**Title Summary of TTCN CR B category to 34.123-3
for approval Batch 1**
Source RAN WG5
Agenda Item 7.6.5

34.123-3 CR 1270 rev - Current version: 5.0.0

Title:	Addition of NAS WI 12 test case 12.3.2.7 to NAS ATS V5.0.0		
Source:	3GPP TSG RAN WG5 (Testing)		
Work item code:	N/A	Date:	01/04/05
Category:	B	Release:	Rel-5
	<i>Use one of the following categories:</i> F (correction) A (corresponds to a correction in an earlier release) B (addition of feature), C (functional modification of feature) D (editorial modification) Detailed explanations of the above categories can be found in 3GPP TR 21.900 .		<i>Use one of the following releases:</i> 2 (GSM Phase 2) R96 (Release 1996) R97 (Release 1997) R98 (Release 1998) R99 (Release 1999) Rel-4 (Release 4) Rel-5 (Release 5) Rel-6 (Release 6)

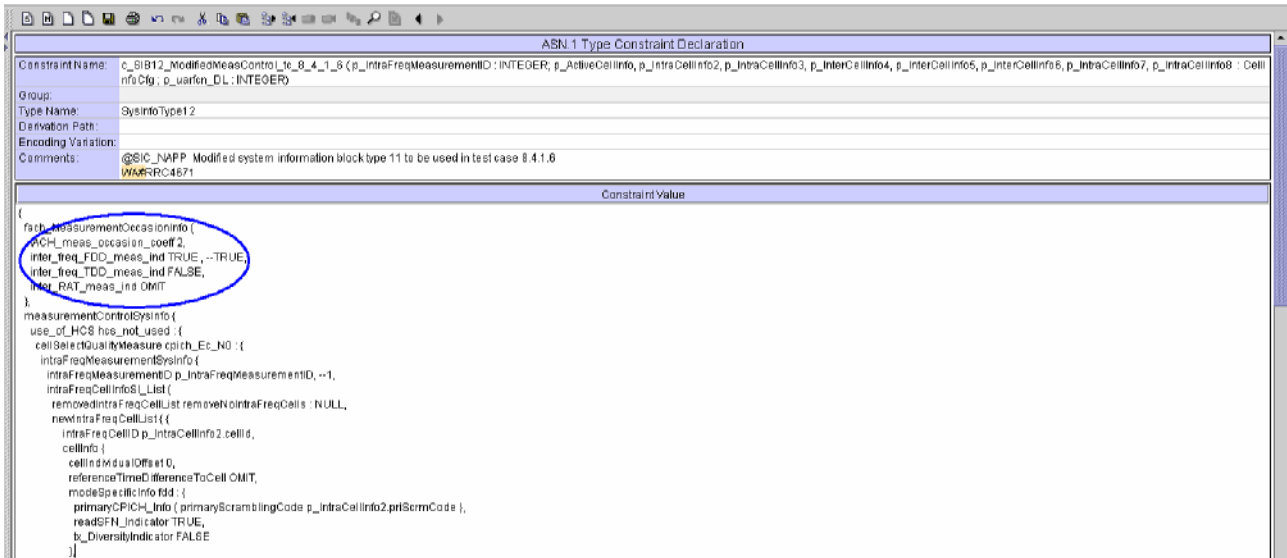
Reason for change The TGPS Status must be set to Activate according to the prose.

Summary of change Created new constraint .

96.11 cds_PhyChReconf64k_PS_ToFACH_Compress (WA#RRC4679)

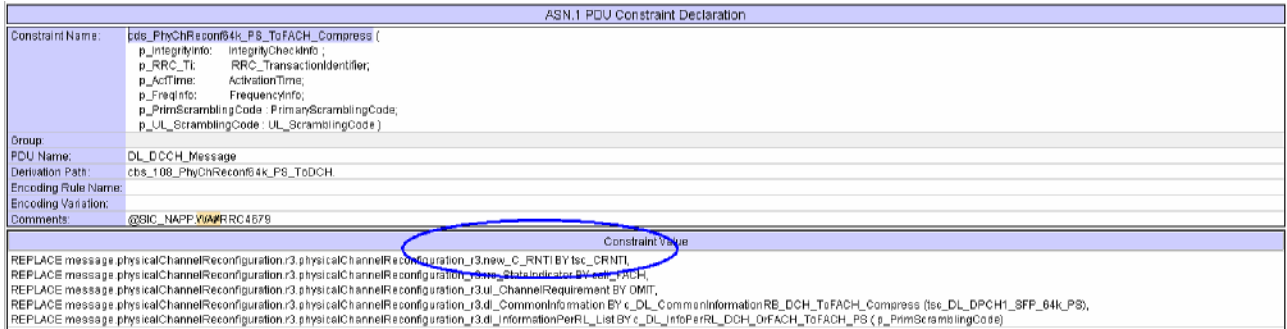
Constraint name	cds_PhyChReconf64k_PS_ToFACH_Compress
Reason for change	C-RNTI is required when UE moved to FACH.
Summary of change	Included C-RNTI.
Source of change	New Change
Label	WA#RRC4679
